CALIFORNIA COASTAL COMMISSION

COASTAL DEVELOPMENT PERMIT APPLICATION CONSENT CALENDAR

Application number3-00-082
Applicant.....Norm Pressley
Project location.....Adjacent to Pescadero Creek in the riparian corridor below unimproved Second Avenue between North Camino Real and Lopez, City of Carmel-by-the-Sea, Monterey County (APN 010-233-006) See Exhibit 1.
Project descriptionDemolition of the remnants of a 392 sq.ft. single family dwelling destroyed by fallen tree in 1995 winter storm and construction of an approximately 1,196 sq.ft., two story single family dwelling on a steep sloping 3,629 sq.ft. lot. See Exhibit 2.
Approvals ReceivedCity of Carmel-by-the-Sea, February 23, 2000
File documents.....Categorical Exclusion E-77-13 for City of Carmel-by-the-Sea; Use Permit 00-04 / DS 99-01, VA 00-04/EA 00-02
Staff recommendation ...**Approve with Conditions**

GEOTECHNICAL REVIEW MEMORANDUM

EXHIBIT NO. 3
 APPLICATION NO. 3-00-082
 Project Site Plan
 California Coastal Commission

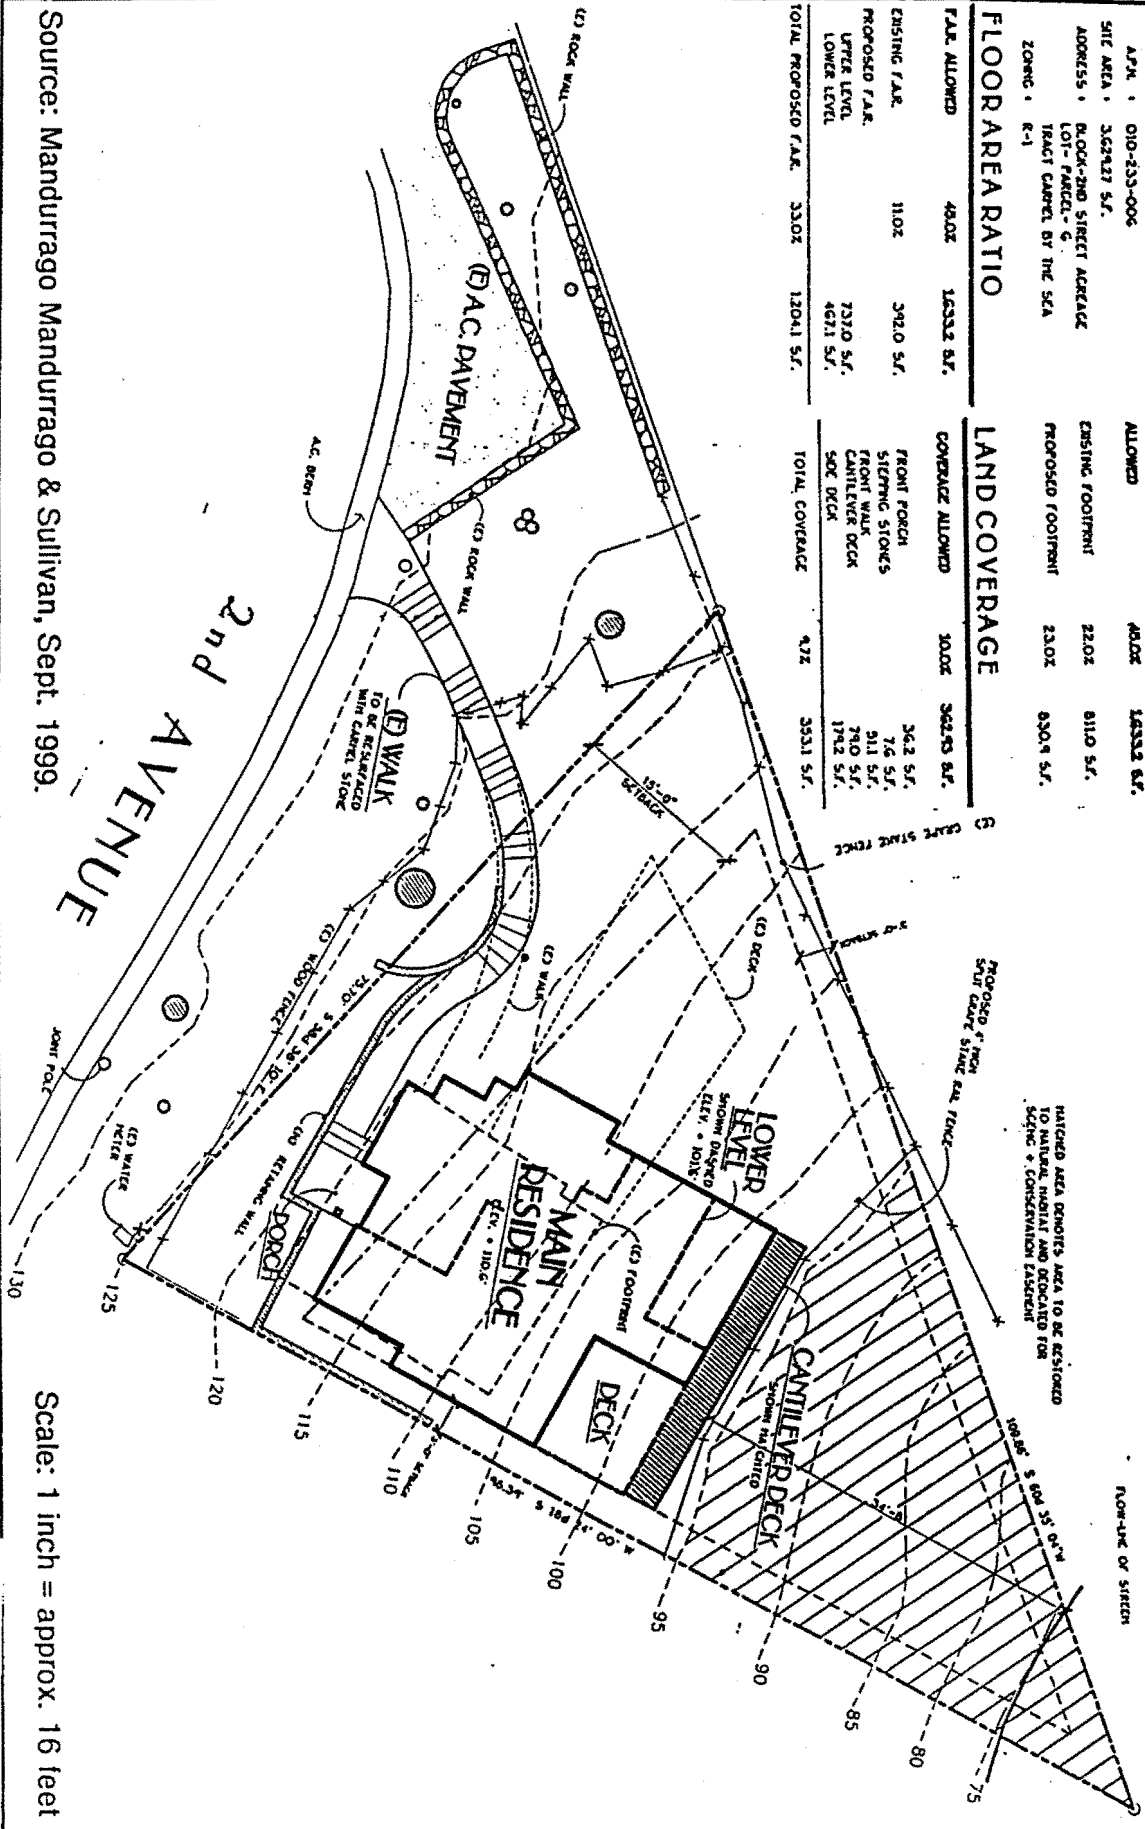
The triangular lot associated with this project is 3,629 square feet and is substandard in size according to the City's current standards for building sites (Exhibit 3). The Applicant proposes to completely demolish a small cottage (built in 1933) that was destroyed by a falling tree in winter 1995 storms (Exhibit 4). Currently all that remains on the site are some deteriorating foundation planking sitting atop timber piers. The Applicant now proposes to demolish what is left and construct an approximately 1,196 square foot house with 350 square feet of walkway and decking in its place (Exhibit 5). The new two-story house is larger in square footage than the previously destroyed house, but the proposed development footprint of approximately 831 square feet is only 20 square feet larger (approximately 2.5%) than the existing 811 square foot footprint (which includes a large deck). The footprint would be in the same general location and slightly reoriented. It would extend about 19 feet farther toward Pescadero Creek. The proposed footing for the new structure requires 240+ cubic yards of grading. Because of its larger size, height, and bulk, it would be more visible than the pre-existing house. In order to accommodate the additional size and bulk of the structure, City staff granted a variance to the standard front yard setback for new development. As mitigation for the direct removal and substantial disruption of habitat values presented by the project, the City required the Applicant to convey a Scenic and Habitat Conservation Easement over the northern quarter of the parcel (880 square feet), measured from the centerline of the creek. Though the proposed development is located in an urban-rural boundary area that is heavily vegetated, the City's permit did not contain a special condition requiring fire clearance around the development. There are no fire clearance requirements in the City's planning code.

EXHIBIT NO. 6
APPLICATION NO. 3-00-082
Pescadero Canyon Cross-section
California Coastal Commission

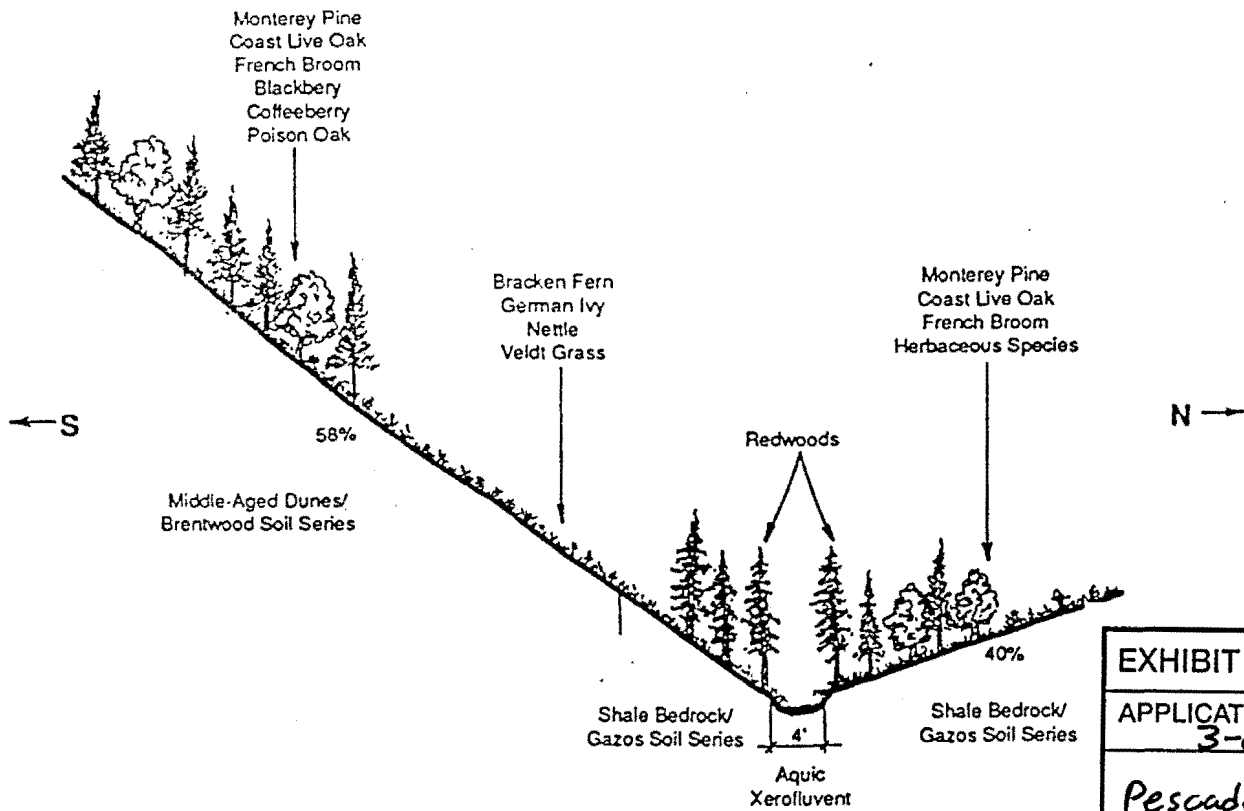
The understory is an integral part of the Monterey pine forest habitat. The dense forest understory layer on applicant's parcel is comprised of invasive horticultural species, native shrub, and herbaceous species. Examples of some of the native shrub and herbaceous species present in Pescadero Canyon include California blackberry (*Rubus ursinus*), flowering current (*Ribes sanguineum*), coffeeberry (*Rhamnus californica*), sticky monkeyflower (*Mimulus auranticus*), snowberry (*Symphoricarpos mollis*), bracken fern (*Pteridium aquilinum var. pubescens*), melic grass (*Melica aff. Imperfecta*), gooseberries (*Ribes malvaceum*) and California hedge-nettle (*stachys bullata*). See Exhibit 6.

EXHIBIT NO. 7
APPLICATION NO. 3-00-082
Pescadero Canyon ESHA Boundary
 California Coastal Commission

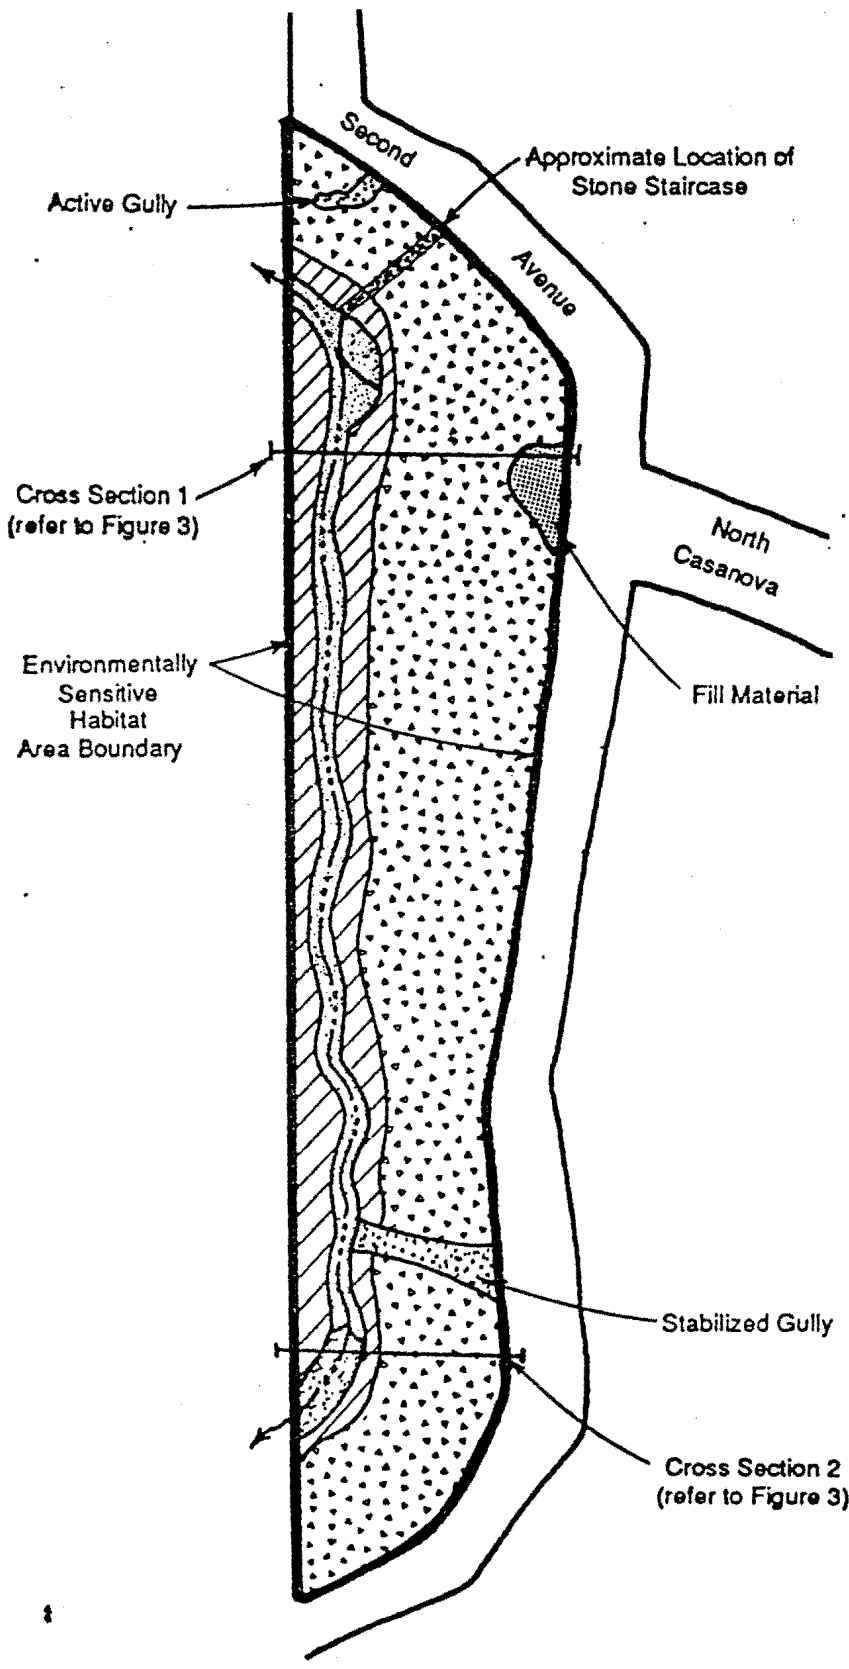
The Redondo Trail is a traditional part of the Del Monte Forest equestrian trail network, parallel to Pescadero Creek. It runs from Carmel beach to points further inland and faces the subject site directly across the creek. Pebble Beach Corporation collects a toll for vehicles entering 17-mile drive, but has not exacted a toll for pedestrian access. The trail network is illustrated in the Del Monte Forest Land Use Plan as part of Monterey County's Local Coastal Plan. The originally constructed trail had elaborate rockwork and was very popular with equestrians, but presently is increasingly in a state of disrepair. In time, we might look forward to the trail being rehabilitated as a link in the California Coastal Trail system. The house as it previously existed was visible from the Redondo Trail. The proposed new structure can also be expected to be in view, but because of its additional size and its current proposed location (31' from Pescadero Creek), would have a more significant impact on the trail user experience (Exhibit 8).
